KING'S CROSSING VILLAGE

SITE PLAN WITH ADJUSTMENTS

KING'S CROSSING VILLAGE
SITE PLAN WITH ADJUSTMENTS
15660 E 6TH AVE, AURORA, CO 80011
COVER SHEET

1 SITE DEVELOPMENT PLAN
PH-02 SCALE: 1/16" = 1' - 0"

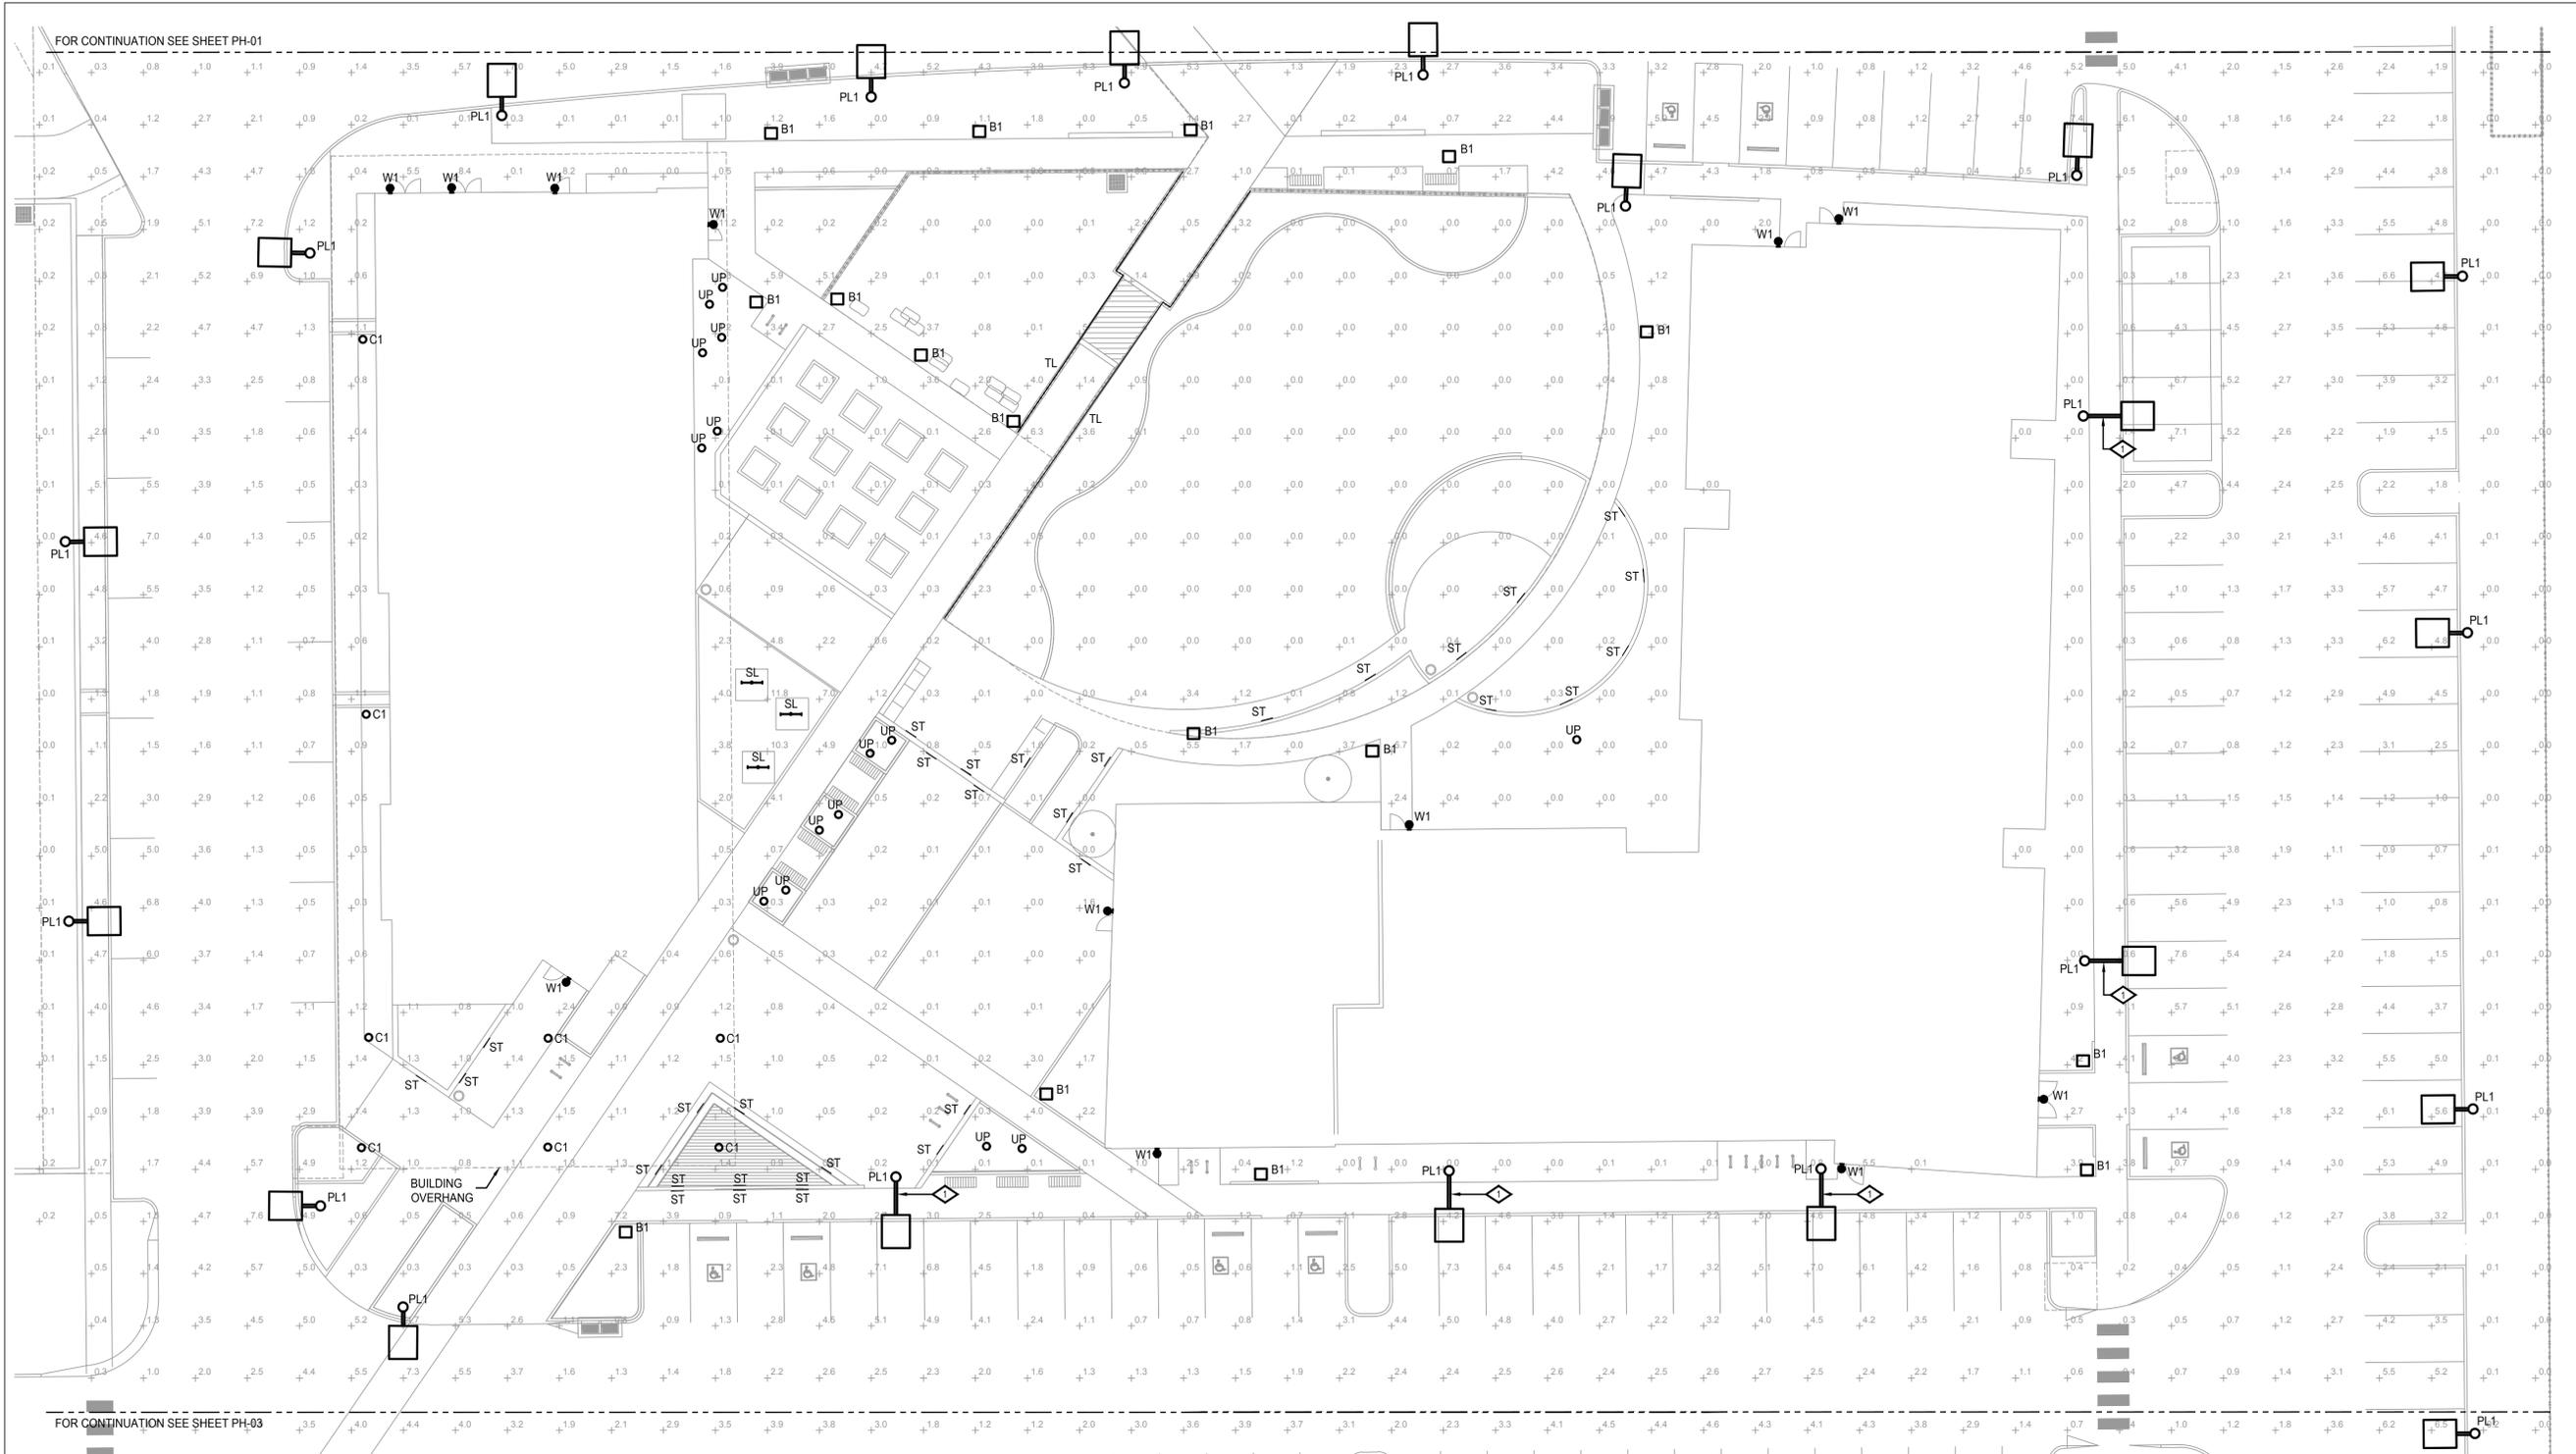
The photometric plan must show and label the location of the internal site accessible route. Provide a minimum of 1 foot-candle of lighting within the accessible route.

ACCESSIBLE ROUTE NOW SHOWN ON PHOTOMETRIC PLANS.

1 SITE DEVELOPMENT PLAN

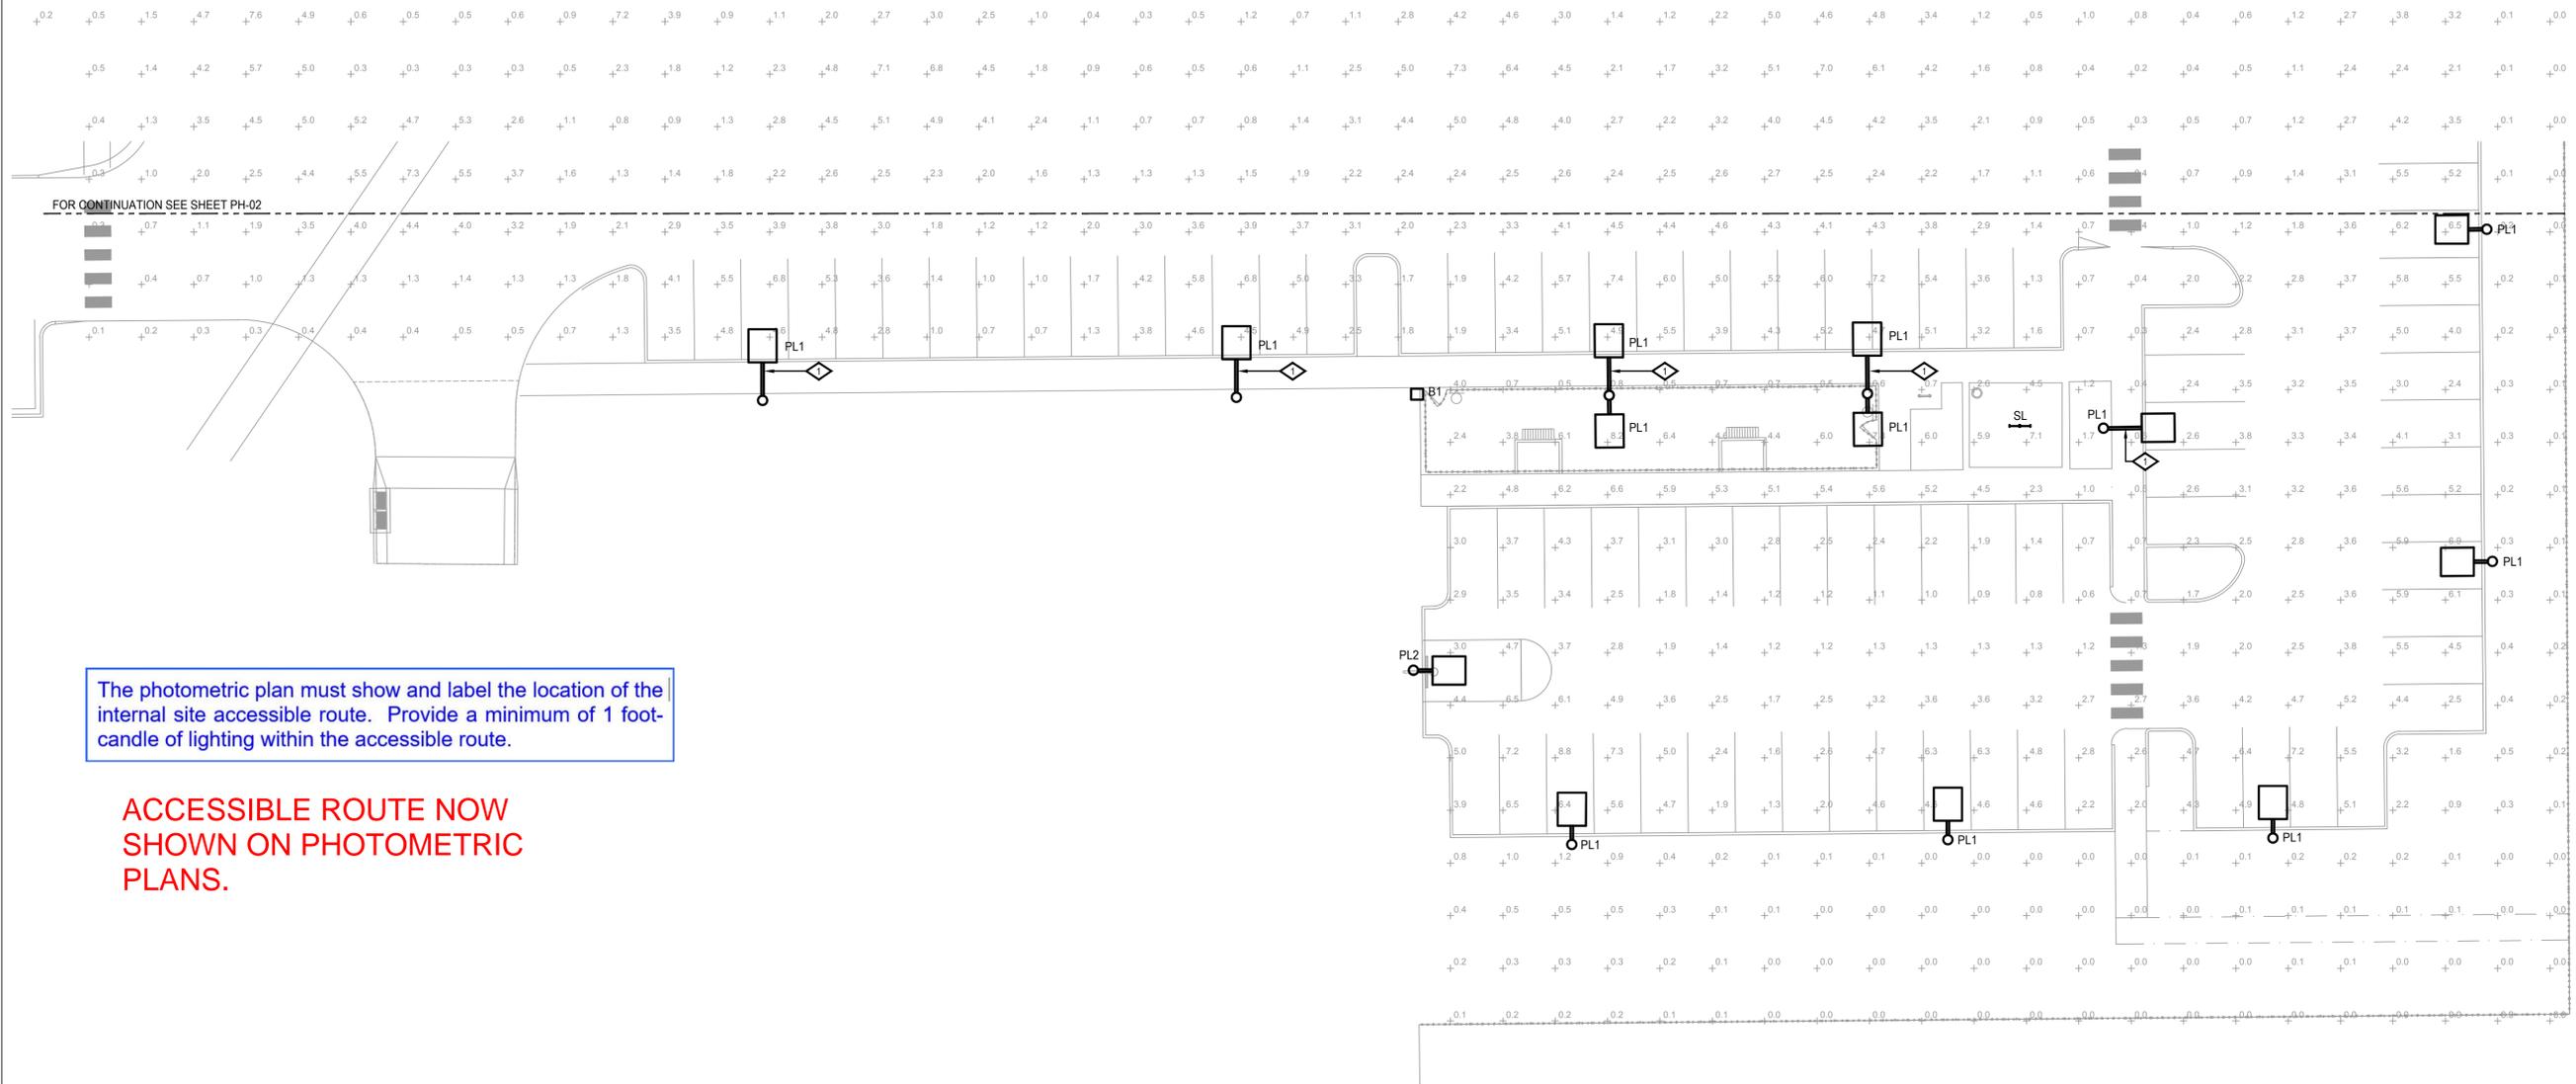
The photometric plan must show and label the location of the internal site accessible route. Provide a minimum of 1 foot-candle of lighting within the accessible route.

ACCESSIBLE ROUTE NOW SHOWN ON PHOTOMETRIC PLANS.
